Defective Groundwater Protection Practices at the Sandia National Laboratories' Mixed Waste Landfill – The Sandia MWL dump.
- Version December 30, 2010

Robert H. Gilkeson, Registered Geologist
PO Box 670
Los Alamos, NM 87544
505 412-1930
rhgilkeson@aol.com

David B. McCoy, Executive Director
Citizen Action New Mexico
POB 4276
Albuquerque, NM 87196-4276
505 262-1862
dave@radfreenm.org

Figure ES-2. Map of the Sandia Mixed Waste Landfill (Sandia MWL dump) showing the monitoring well network in 2007 of the six monitoring wells MW1 to MW6 and the background water quality well BW1 500 feet south of the dump.

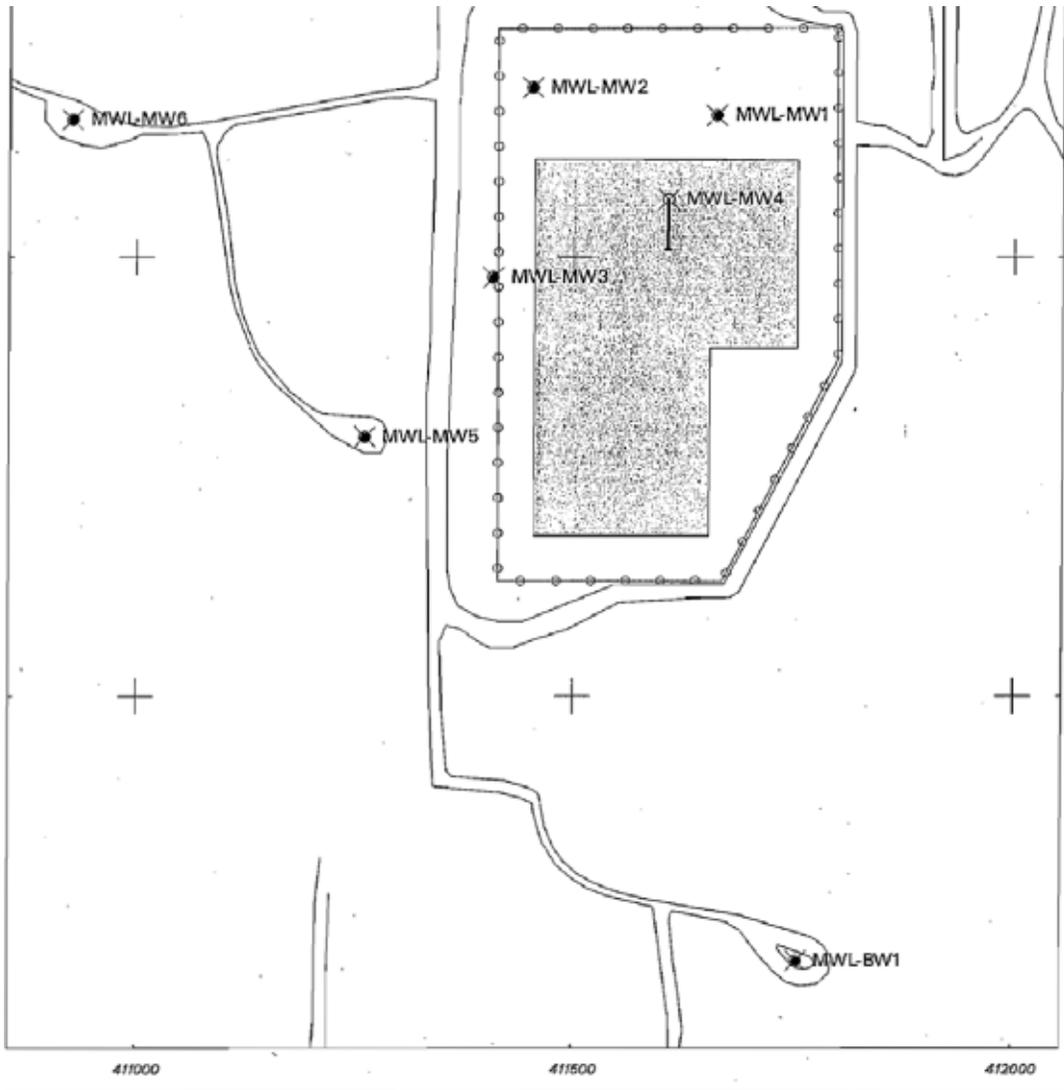
This review of the monitoring wells by Mr. Gilkeson and Citizen Action has determined that only two of the six contaminant detection monitoring wells displayed on Figure ES-2 (i.e., wells MWL-MW1 and -MW3) were at locations that could detect groundwater contamination from the Sandia MWL dump.

Of the seven monitoring wells displayed on Figure ES-2, only two monitoring wells MWL-MW1 and -MW3 were installed at locations that could detect groundwater contamination from the MWL dump. A review of the water quality data from the two monitoring wells MWL-MW1 and -MW3 shows that the wastes buried in the MWL dump have contaminated the groundwater with the RCRA listed wastes cadmium, chromium, nickel and nitrate first seen in groundwater samples collected from 1990 and later. The nickel groundwater contamination from the wastes buried in the dump increased over time.

Historically, only one monitoring well was installed in the ARG Deposits. This is well MWL-MW6 on Figure ES-2. The intended purpose of well MWL-MW6 was to monitor at the water table in the fine-grained alluvial fan sediments but Figure ES-4 shows that the well screen was installed in the deeper layer of ARG Deposits because of mistakes in installing the monitoring well. The monitoring well MWL-MW6 is too distant for RCRA compliance at over 500 feet from the MWL dump.

The above statement in the WERC 2003 Final Report is entirely incorrect as shown above in Sections ES-7 to ES-11. Figure ES-2 shows that only two of the monitoring wells (i.e., wells MWL-MW1 and -MW3) were at locations “drilled around the perimeter” of the MWL dump. The intercomparison of Figures ES-2, ES-4 and ES-6 shows that well MWL-MW3 was the only hydraulically downgradient monitoring well installed at the water table and there was no hydraulically upgradient monitoring well for background water quality. The NMED 1998 NOD Report recognized that the monitoring well installed inside the unclassified area (i.e., well MWL-MW4) was not reliable to detect groundwater contamination from the MWL dump.

Figure ES-3. Location of the new detection monitoring wells MWL-MW7, -MW8 and -MW9 along the western boundary of the Sandia MWL Dump and the new background monitoring well MWL-BW2 200 feet east of the MWL Dump. The four new monitoring wells were installed in 2008.

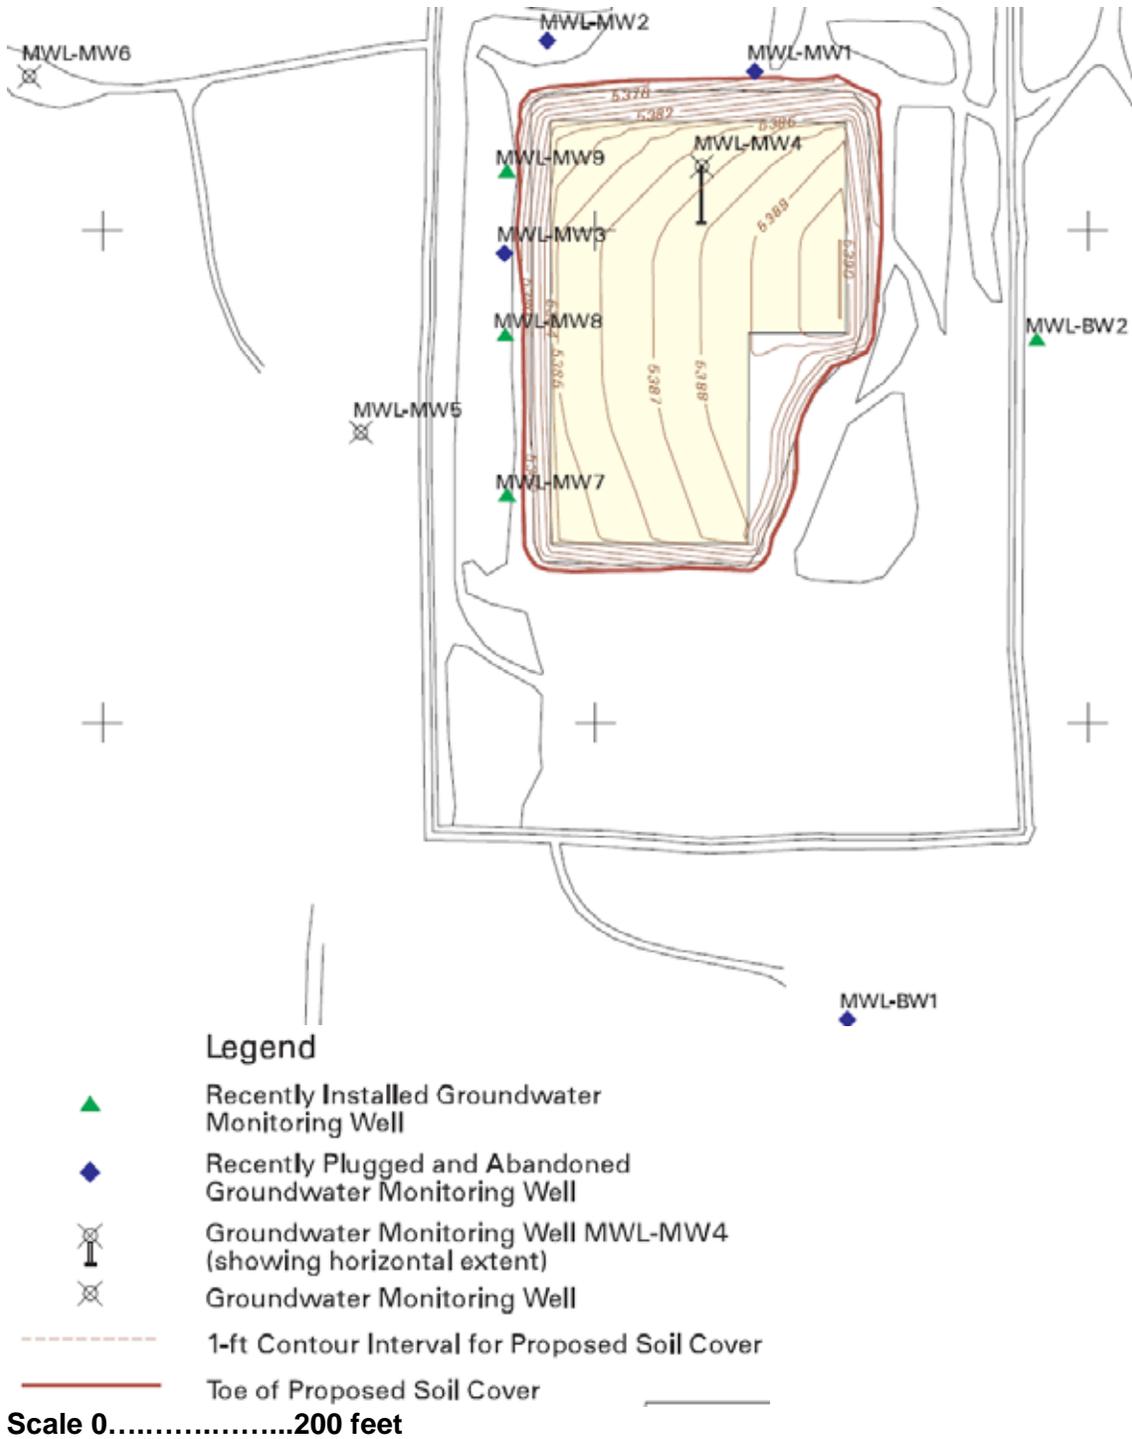
Another important issue is that none of the six contaminant detection monitoring wells in the current monitoring well network on Figure ES-3 are able to detect groundwater contamination from the Sandia MWL dump. The NMED HWB should correct its mistake to approve all of the unreliable monitoring wells and to allow DOE/Sandia to use the unreliable monitoring wells for future long-term monitoring of the Sandia MWL dump.

The NMED HWB has not, but should require replacement of the unreliable monitoring wells as is required by the April 29, 2004 Consent Order (p.63) for monitoring wells that do not serve their intended purpose. Figure ES-3 shows that the two unreliable monitoring wells MWL-MW5 and -MW6 are in the current network of monitoring wells. In addition, DOE/Sandia proposes to use the two unreliable monitoring wells that do not allow accurate assessment of groundwater contamination in the long-term monitoring and maintenance plan for the MWL dump (DOE/Sandia, 2007).

In the current network of seven monitoring wells on Figure ES-3, the six contaminant detection monitoring wells MWL-MW4, -MW5, -MW6, -MW7, -MW8 and -MW9 are not usable 1). to monitor contamination at the water table below and downgradient from the MWL dump or 2). to measure the elevation of the water table below and hydraulically downgradient of the MWL dump. Except for well MWL-MW6, the six wells are unusable for any purpose. The NMED Sandia Consent Order requires that the six defective wells be plugged and abandoned and replaced as follows:

Figure ES-4. Schematic of the Monitoring Wells and the Hydrogeologic Setting at the Sandia MWL dump. The permeable sands and gravels in the Ancestral Rio Grande "A Deposits (ARG deposits) are the valuable groundwater resource for Albuquerque and the surrounding region.

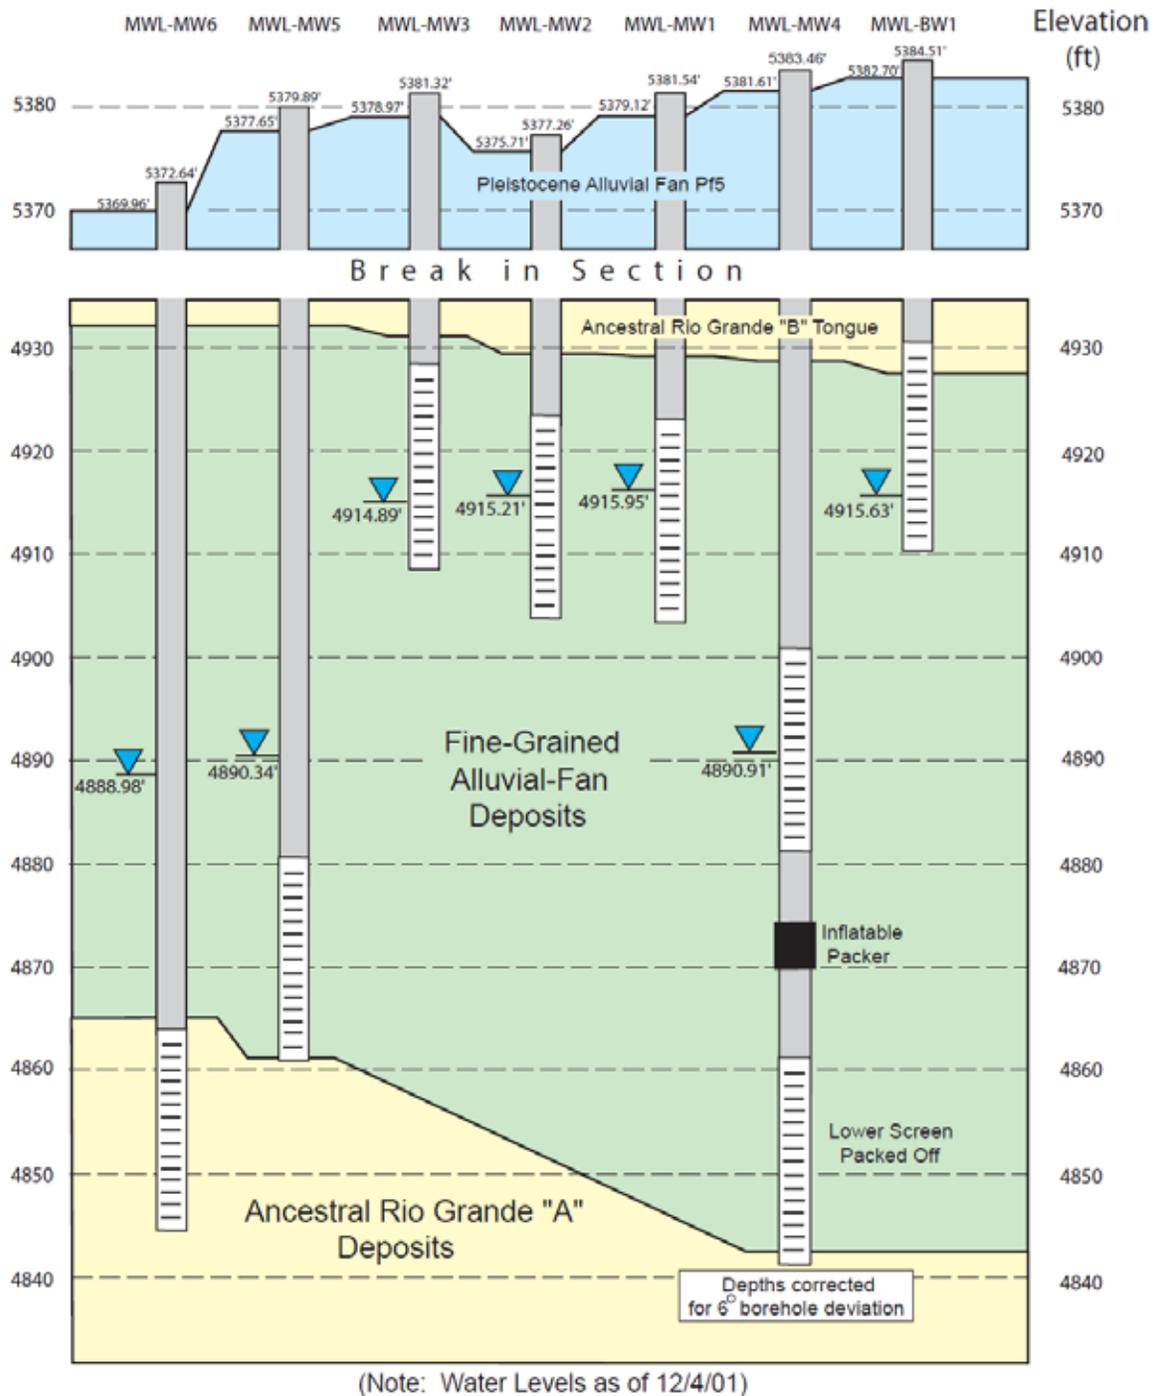
- 2). The deeper zone that requires a network of monitoring wells is the layer of Ancestral Rio Grande "A" Deposits (ARG Deposits) that are shown below the layer of fine-grained alluvial fan sediments on Figure ES-4. The ARG Deposits are the highly productive aquifer that provides large supplies of groundwater to the Albuquerque drinking water wells and the supply wells at Sandia and at Kirtland Air Force Base. The NMED HWB has not, but should enforce the requirement in RCRA and the NMED Sandia Consent Order for a network of monitoring wells in the ARG Deposits.

The installation of the upper screen in well MWL-MW4 too deep below the water table is displayed on Figure ES-4. The NMED has not, but should require replacement of the defective monitoring well. Many DOE/Sandia reports present the unreliable water quality data collected from the defective well MWL-MW4 for the incorrect conclusion that the MWL dump has not contaminated the groundwater below the Sandia MWL dump.

As described above, Figure ES-4 shows that the screens in wells MWL-MW4, -MW5, and -MW6 are installed too deep below the water table. The three defective wells require replacement. The NMED HWB has not enforced the requirement in the Sandia Consent Order, the 1998 NMED NOD Report and RCRA for replacement of the three defective monitoring wells.

Figure ES-5. The regional water level contour map in the *Sandia 2008 Mixed Waste Landfill Annual Groundwater Monitoring Report*. The map incorrectly shows the direction of groundwater travel below the MWL dump is to the northwest. The MWL dump is at the center of the figure.

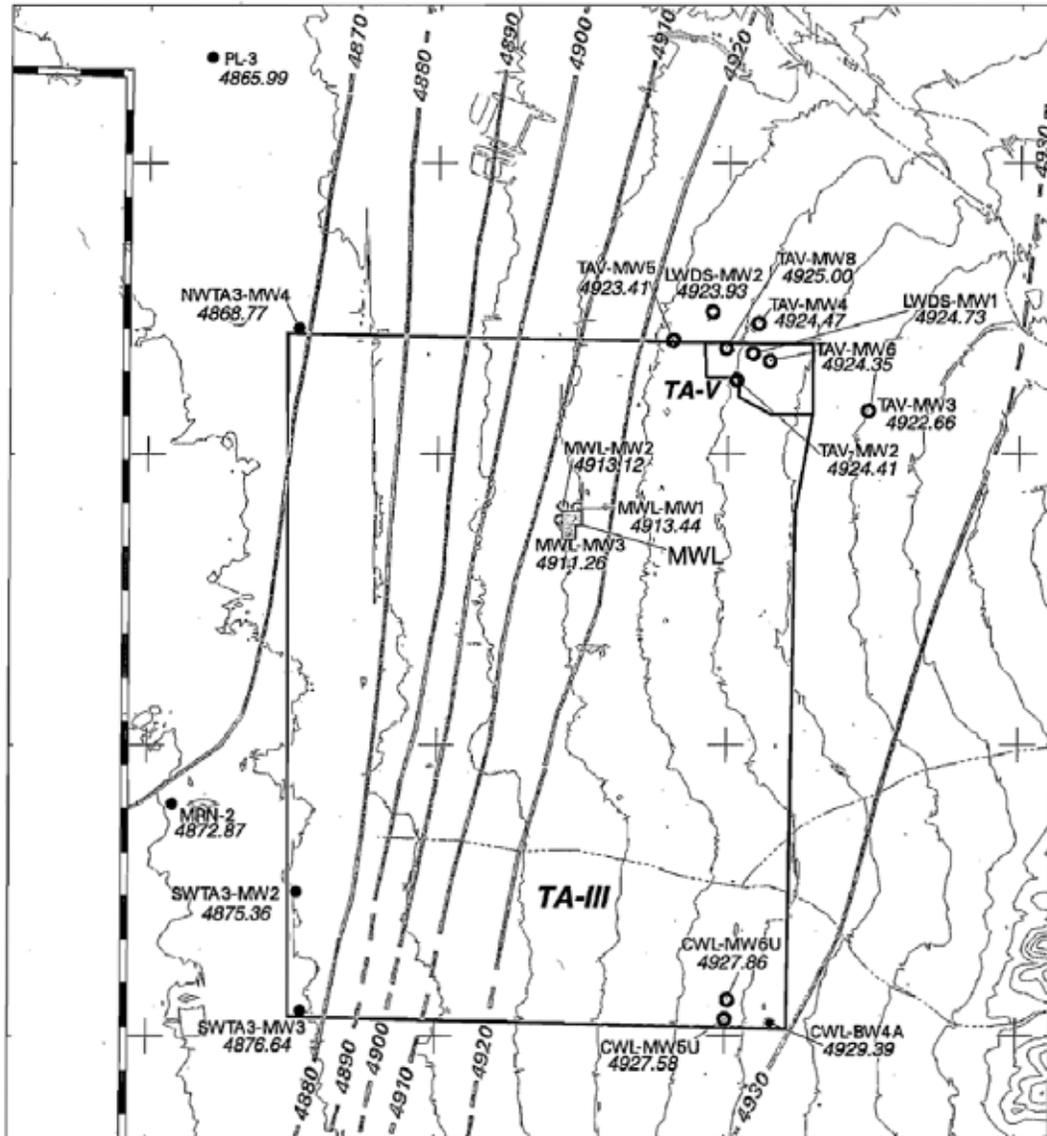
The water table contour map in Figure ES-5 shows the incorrect northwest flow of groundwater below the MWL dump that was presented in the DOE/Sandia 2008 Report. However, it is important to note that the water table elevations posted on Figure ES-5 for the three monitoring wells MWL-MW1, -MW2 and -MW3 show that the actual direction of groundwater flow below the MWL dump is to the **southwest**.

Figure ES-6. Water table contour map for the southwest direction of the groundwater flow at the water table below the Sandia MWL dump.

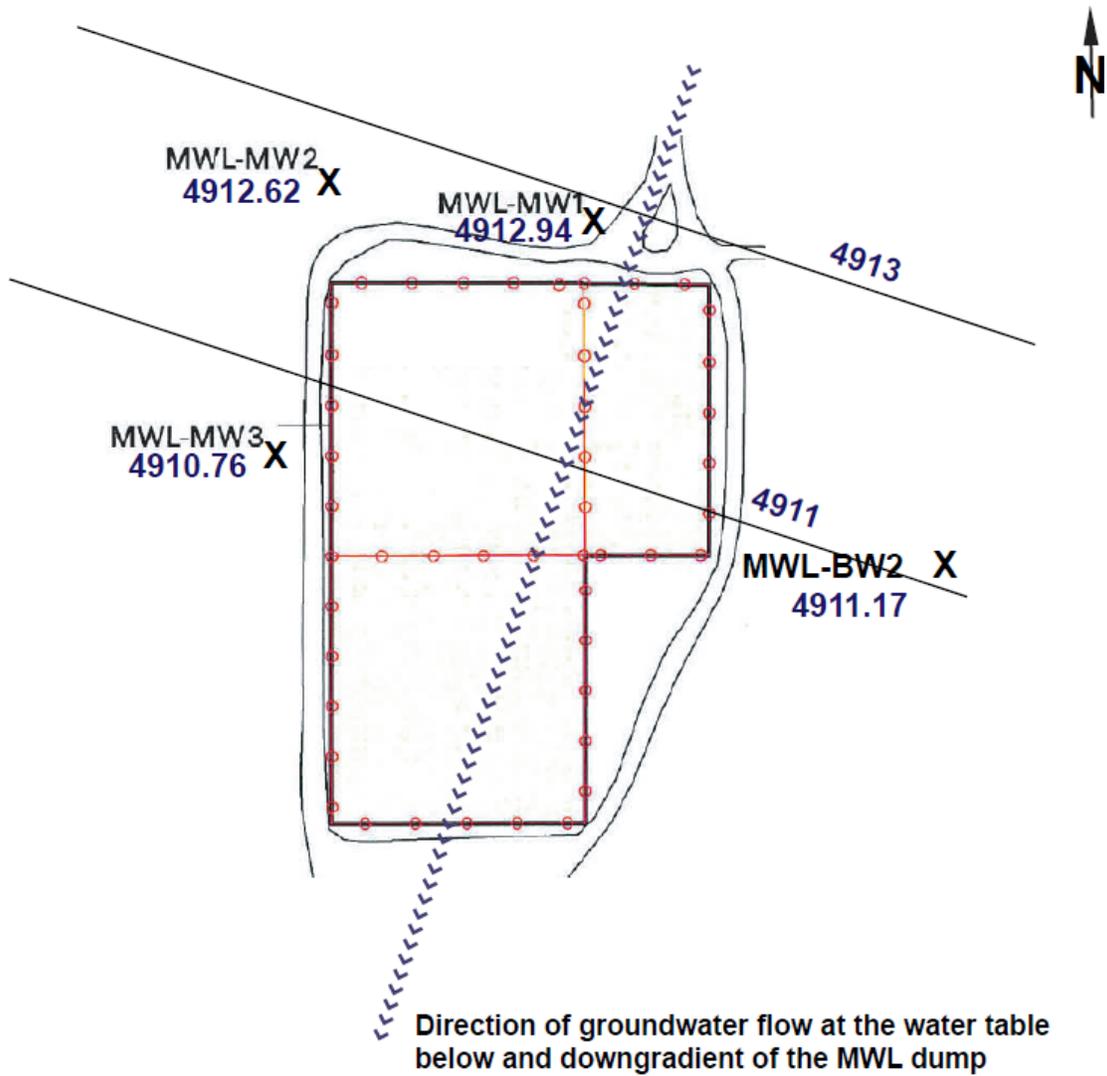
Figure ES-6 presents the best available knowledge on the southwest direction of groundwater flow below the MWL dump because the direction of groundwater flow is based on the water table elevation measured in the three monitoring wells MWL-MW1, -MW2, -MW3 and also in the new monitoring well MWL-BW2 that was installed in 2008. Figure ES-6 shows the continuing important need and RCRA requirement for monitoring wells to be installed on the south side of the Sandia MWL dump.

Figure ES-7. Comparison of 1995 and 2008 Tritium sediment sample analytical results for the 10-, 30- and 50-foot depth samples at the Sandia MWL dump.

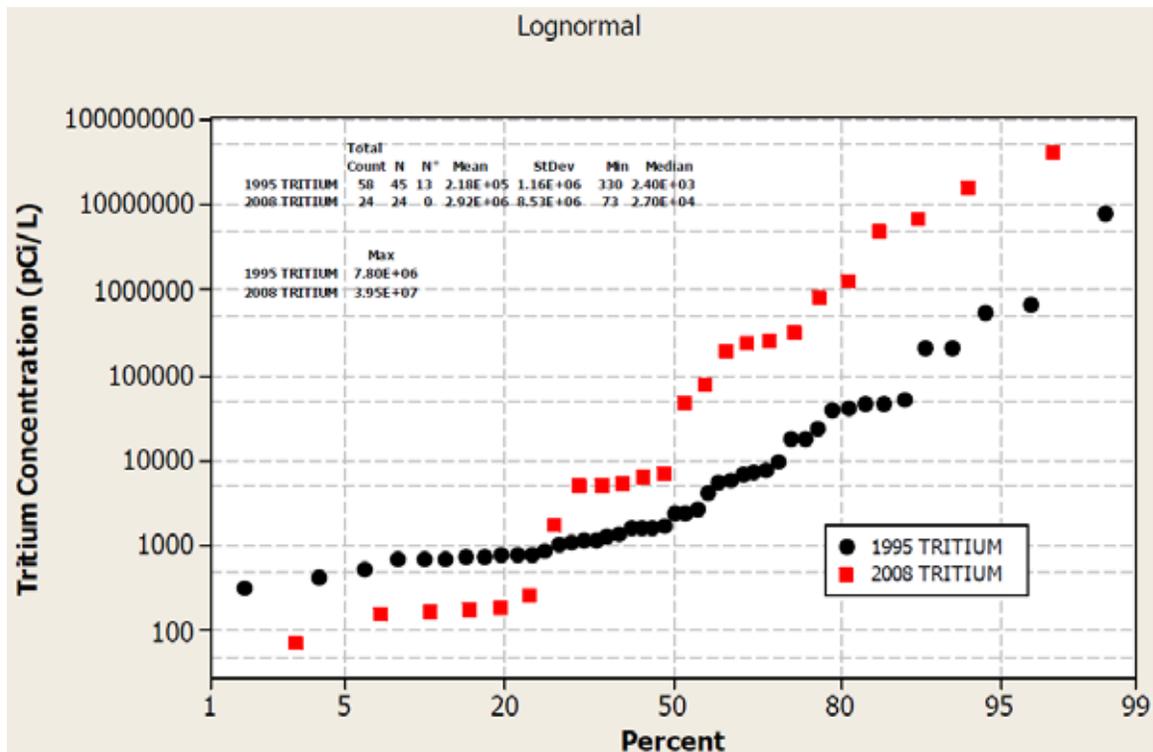
The large increase in tritium concentrations measured in the DOE/Sandia 2008 field investigation is displayed in Figure ES-7 and is direct evidence of a new large release of tritium contamination and possibly other contamination including VOCs and heavy metals from the wastes buried in the unlined pits and trenches at the MWL dump. The actual increase in tritium and other contamination below the MWL dump is not known because of the sparse number of boreholes in the 2008 field investigation. None of the six boreholes were
